Technical Bulletin 18-2

INSTALLING CPI MODEL P55 PUMPS IN SKF/LINCOLN MODULAR LUBE LUBRICATORS

Technical Bulletin regarding the use of CPI's P55 vacuum pumps (model numbers 6501800P55V301S, V401S, V601S) with applicable Lincoln lubricator boxes.

Figure 2: Interference location between pump suction tube strainer and camshaft mounting block.

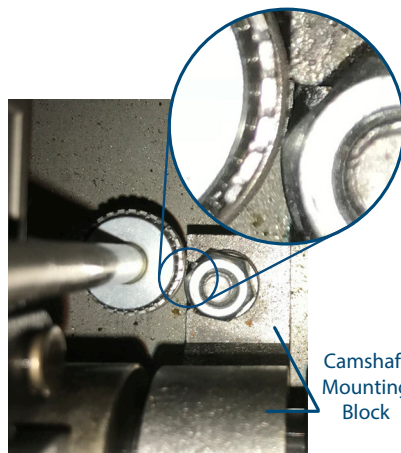
Interference may occur during pump installation between the pump suction tube strainer and the lubricator camshaft mounting block. The potential interference issue is limited to only the pump location adjacent to the lubricator camshaft mounting block (reference Figures 1-3). If the pump installs correctly in this location, then no further action is required. If the pump experiences interference during installation, the following options are recommended:

Option 1. Use a different pump location in the lubricator. This option requires rerouting the applicable discharge tubing line, but retains the pump suction tube strainer assembly.

Option 2. Remove the suction tube strainer assembly. Removing the strainer assembly is not an issue for applications using filtered, clean oil in the lubricator and routine maintenance practices. Grip the suction tube with pliers to prevent the tube unthreading from the pump body. Remove the strainer and unthread the strainer body from the suction tube (Figures 3-4). The suction tube is installed into the pump body with sealant to prevent vacuum leaks.
